RESOLUTION SETTING HEARING ON REQUEST FROM PINNACLE ON FLEUR, LLC TO AMEND PUD CONCEPTUAL PLAN FOR PROPERTY LOCATED AT 2710 AND 2500 FLEUR DRIVE

STAFF REPORT TO THE PLANNING COMMISSION

FIRST AMENDMENT TO
THE CONCEPTUAL PLAN
**THE VILLAGE AT
GRAY'S LAKE**
A PLANNED UNIT DEVELOPMENT
IN THE CITY OF DES MOINES,
COUNTY OF POLK, STATE OF IOWA
SHEET 2 OF 2

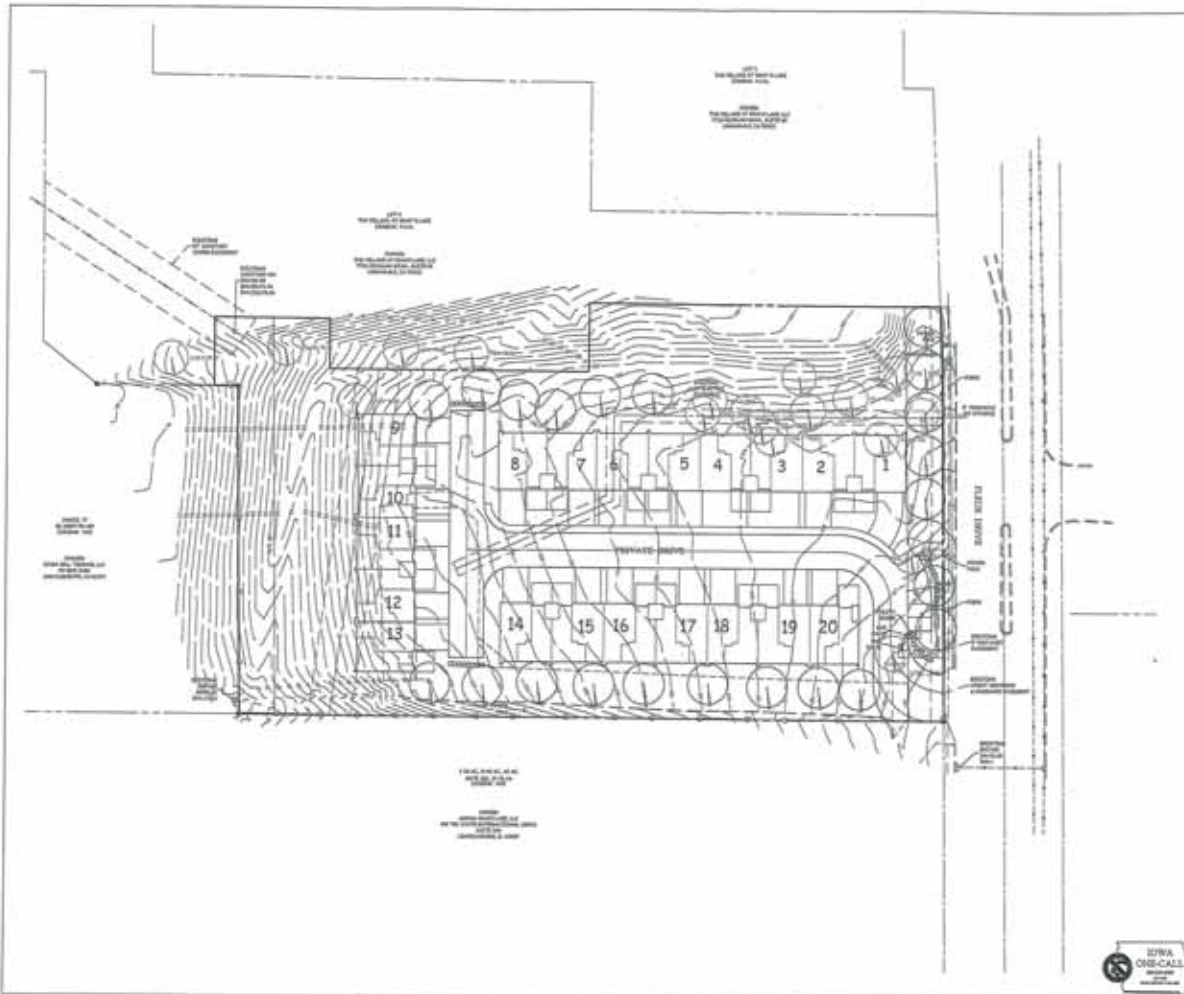
- 1) Addition of a statement as to how stormwater management would be handled with future redevelopment.
- 2) Landscaping requirements should be indicated listing standards reflective of the Conceptually shown landscaping.

- 3) Provide the following notes on the PUD Conceptual Plan Amendment:
 - a. Streetscape: Street Trees should be spaced 30' apart within the right-of-way along each frontage. Trees should be no closer than 15' to a street light.

- b. Frontage Perimeter Landscaping: The required area shall be a minimum of 12-feet in depth measured from the street property line with a 3-foot berm or landscaped screen. Shade trees and shrubs shall be provided at a minimum of 1 tree and three shrubs per 40 lineal feet on center.

- c. Pedestrian access from any building to a street sidewalk shall be provided and clearly marked / striped on site. Lighting along pedestrian walks shall be a maximum of 15' in height.

- d. No new mechanical equipment, meters, transformers, condensers, or other such equipment shall be provided on any street side façade. At minimum, such equipment shall be setback from the street façade a minimum of 15'.

- e. Any mechanical equipment interior to the site shall be softened with landscaping material outside any equipment clearance setbacks.
 - f. Mechanical vents shall not protrude from any street facing façade. A minimum 5' sidewalk is required along each frontage. Identify either indoor or covered bike parking amenities.

- g. Easements shall be provided for shared vehicle/pedestrian ingress/egress between sites and to the public sidewalk.
 - h. Direct light trespass beyond the property lines is prohibited. The maximum horizontal illuminance at grade and the maximum illuminance at five feet above graded measure at the property line shall not exceed illuminating Engineering Society of North America recommended practices for light trespass which is 0.5 footcandles for N districts and 2.0 footcandles for all other districts.

- i. Any Final Development Plan shall discuss the method for trash removal service. If receptacles are not kept within the separate garages for the units, then a screening solution for their outdoor location would need to be shown on the Final Development Plan.

- j. Provisions for permitted site fencing and walls to include heights, design, and materials. Fencing in the front yard between the row townhomes and Fleur should not exceed 4 feet in height.

drain out the entry driveway to an intake to the south in Fleur Drive. Engineering staff has requested that the proposed PUD Conceptual Plan be revised to include a narrative statement on the plan as to how stormwater management would generally be handled with the proposed future redevelopment.
